BPC East and West Sewershed Package 2
Solicitation Number: CO-00551
Job No.: 20-4528

ADDENDUM 3
August 4, 2022

DATE: JULY 2022	SAWS PROJECT NO. 20-4528	SHEET NO. C6
DESIGN: JAF	RWA PROJECT NO.	
DRAWN: JAW	CHECKED: VRS

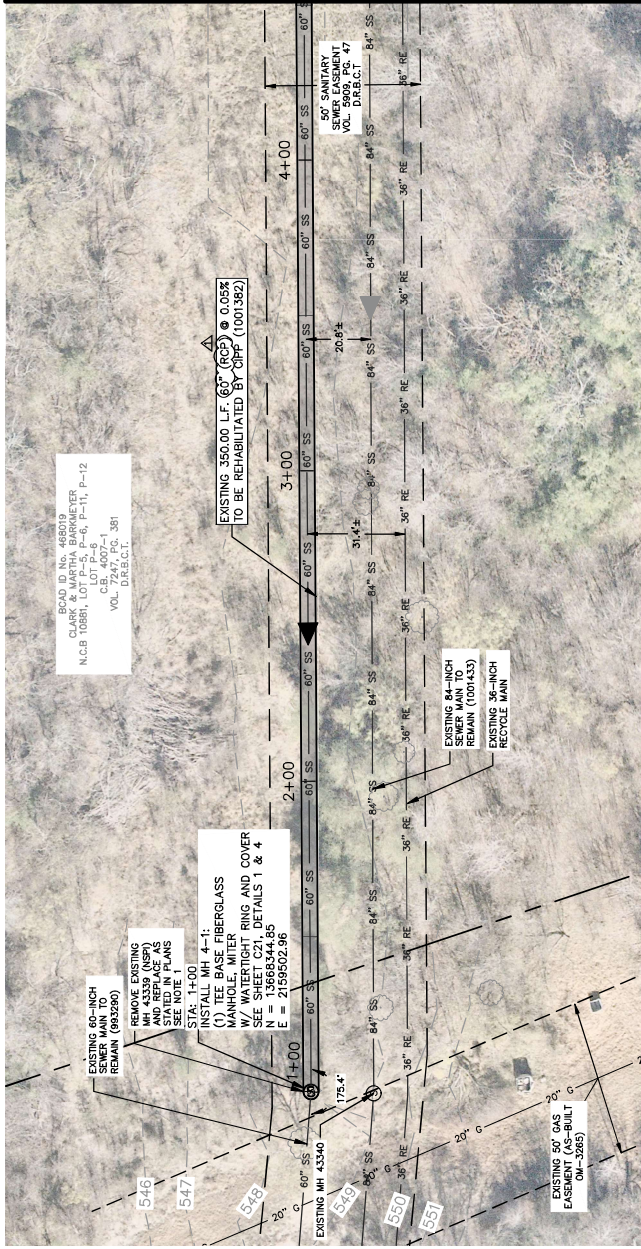
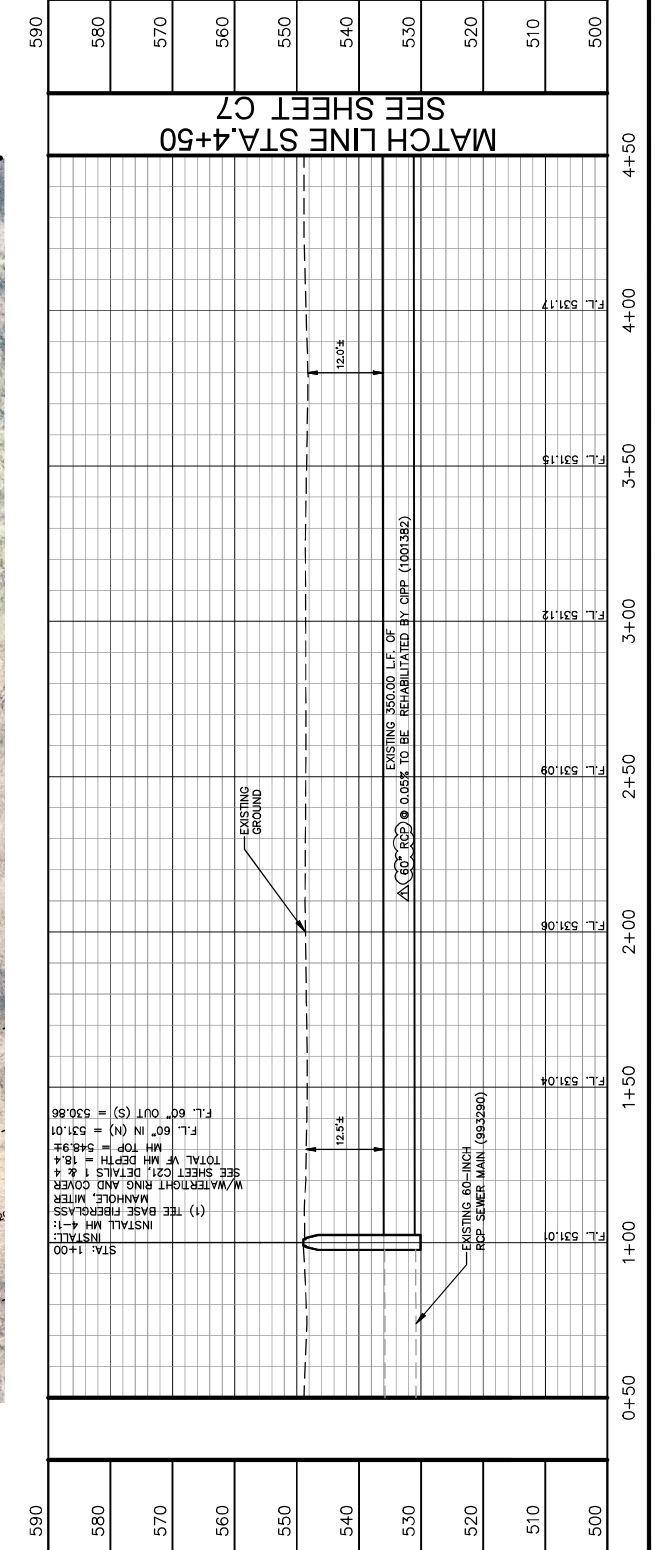
1. Sheet C6– SEG. 3 – ROSILLO CREEK (1001382) (SHEET 1 OF 6) Revise and replace sheet in its entirety.
 - Revise in plan view “Existing 350.00 L.F. 60” FRP of (RCP) @ 0.05% to be rehabilitated by CIPP (10001382)” with the following: “Existing 350.00 L.F. 60” (RCP) @ 0.05% to be rehabilitated by CIPP (10001382)”

- Revise in profile view view “Existing 350.00 L.F. of 60” FRP @ 0.05% to be rehabilitated by CIPP (10001382)” with the following: “Existing 350.00 L.F. 60” RCP @ 0.05% to be rehabilitated by CIPP (10001382)”

Response: Based on review of video, we concur that the material change depicted on the plans does not appear to be correct, and that existing pipe appears to be RCP throughout this segment reach. See revised drawings (C6, C7, and C8) included as part of this addendum.

DATE: JULY 2022	SANS PROJECT NO. 20-4228	SHEET NO. C7
DESIGN: JAF	RWA PROJECT NO. 08666063	
DRAWING: HWY		
CHECKED: VRS

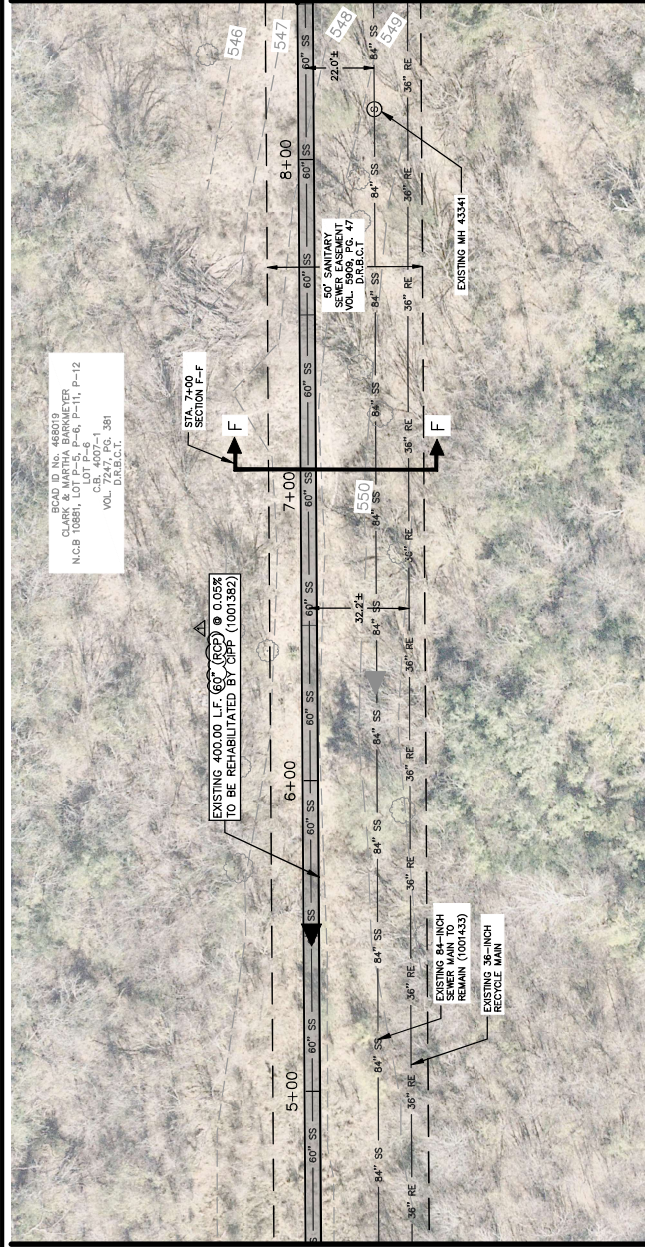
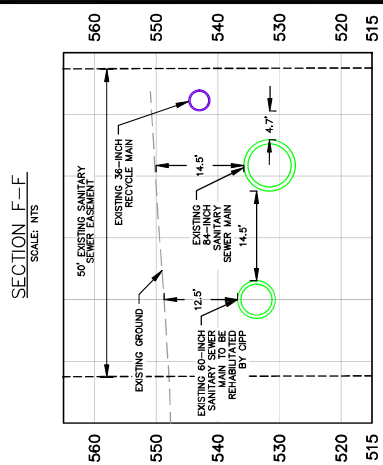
2. Sheet C7– SEG. 3 – ROSILLO CREEK (1001382) (SHEET 2 OF 6) Revise and replace sheet in its entirety.
 - Revise in plan view “Existing 400.00 L.F. 60” FRP of (RCP) @ 0.05% to be rehabilitated by CIPP (10001382)” with the following: “Existing 400.00 L.F. 60” (RCP) @ 0.05% to be rehabilitated by CIPP (10001382)”

- Revise in profile view view “Existing 400.00 L.F. of 60” FRP @ 0.05% to be rehabilitated by CIPP (10001382)” with the following: “Existing 400.00 L.F. 60” RCP @ 0.05% to be rehabilitated by CIPP (10001382)”

DATE: JULY 2022	SAWS PROJECT NO. 20-4528	SHEET NO. C8
DESIGNER: JAF	SHA PROJECT NO.	
DRAWN: HWY	CHECKED: VRS

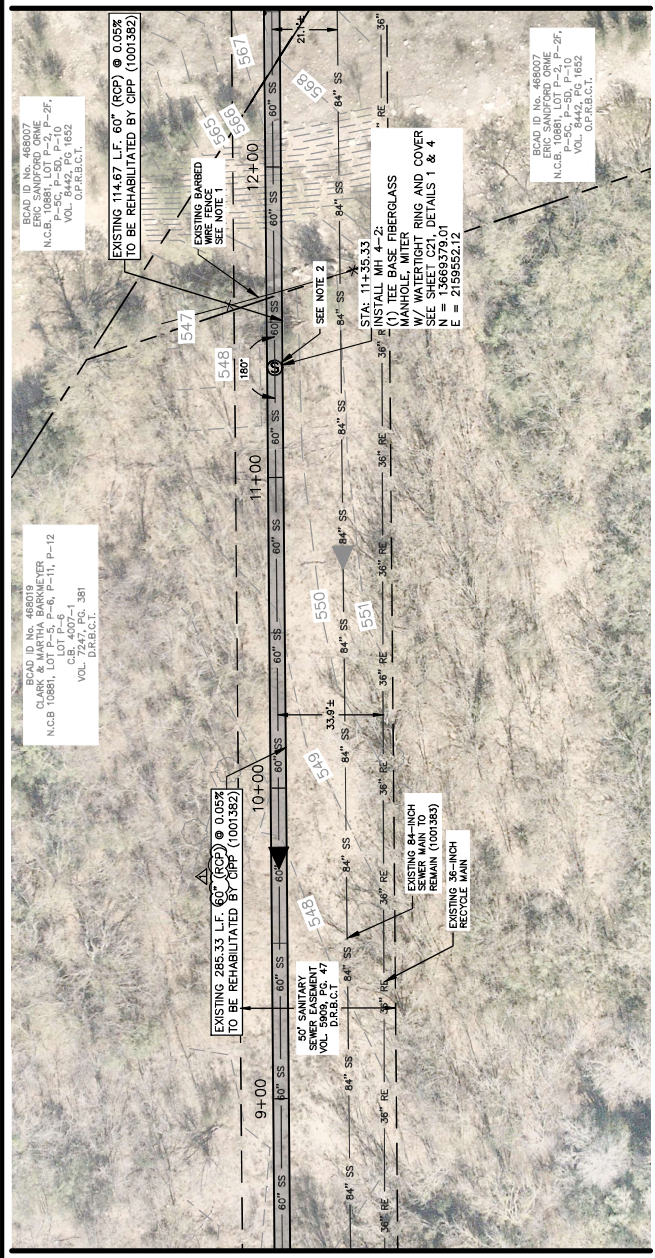
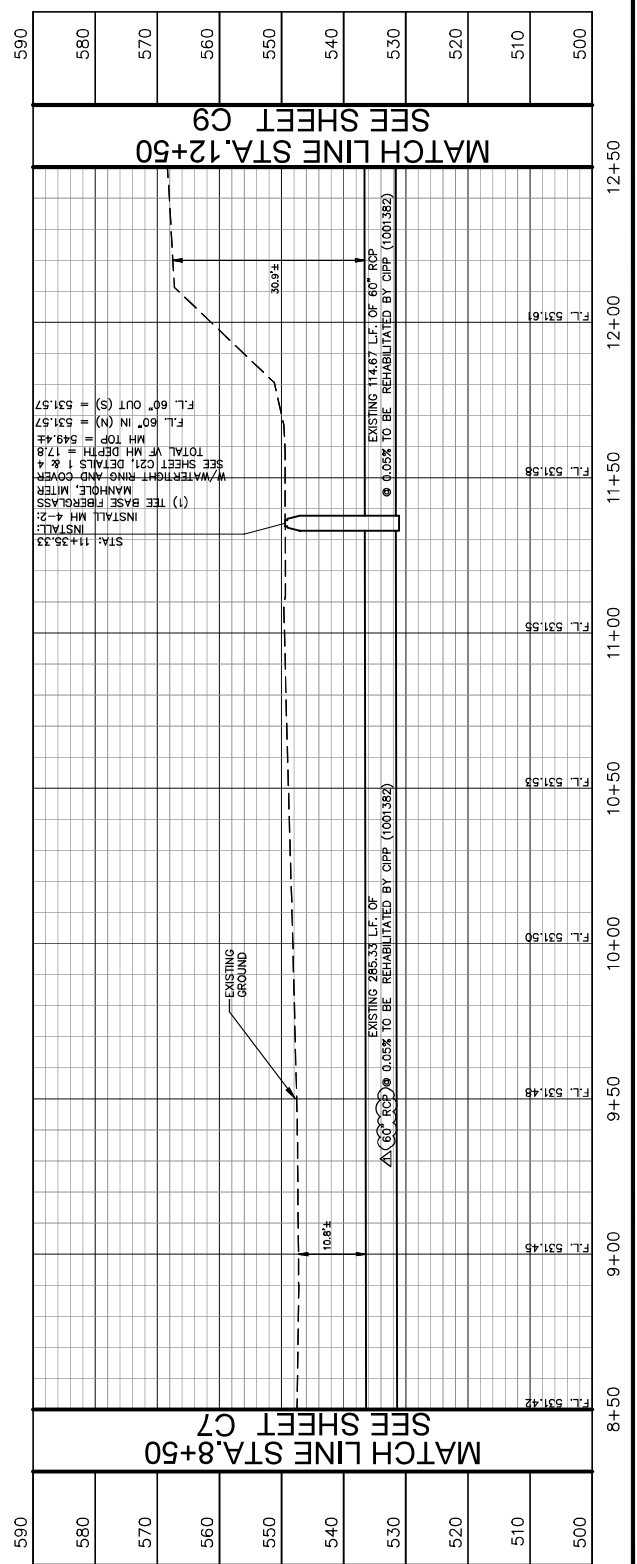
3. Sheet C8– SEG. 3 – ROSILLO CREEK (1001382) (SHEET 2 OF 6) Revise and replace sheet in its entirety.
 - Revise in plan view “Existing 285.33 L.F. 60” FRP of (RCP) @ 0.05% to be rehabilitated by CIPP (10001382)” with the following: “Existing 285.33 L.F. 60” (RCP) @ 0.05% to be rehabilitated by CIPP (10001382)”

- Revise in profile view view “Existing 285.33 L.F. of 60” FRP @ 0.05% to be rehabilitated by CIPP (10001382)” with the following: “Existing 285.33 L.F. 60” RCP @ 0.05% to be rehabilitated by CIPP (10001382)”

4 SEGMENT 2 - BYPASS DISCHARGE POINT DETAIL
SCALE: NTS

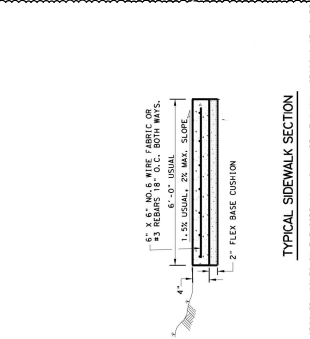
4. Sheet C18 – GENERAL DETAILS (SHEET 2 OF 2) Revise and replace sheet in its entirety.
 - Revise Detail 4 – Segment 2 – Bypass Discharge Point Detail. Add the following notes: “1. Upon completion of bypass operation, any excavation within 10’ of the edge of pavement to be backfilled with flowable fill to 12” below existing ground. The contractor is to include the cost for flowable fill backfill of the excavation area incidental to Item No. 864 – Bypass Pumping for Large Diameter Sanitary Sewer Mains (Segment 2). 2. Contractor to revegetate excavation area to existing or better conditions upon completion of bypass pumping operations.”

- Revise Detail 4 – Segment 2 – Bypass Discharge Point Detail. Revise callout “Flowable fill to be placed at least 18” above pipe crown, and remaining open hole to be filled with native earthen material” with the following: “Where excavation is not within 10’ of the edge of pavement, flowable fill to be placed at least 18” above pipe crown, and remaining open hole to be filled with native earthen material.”
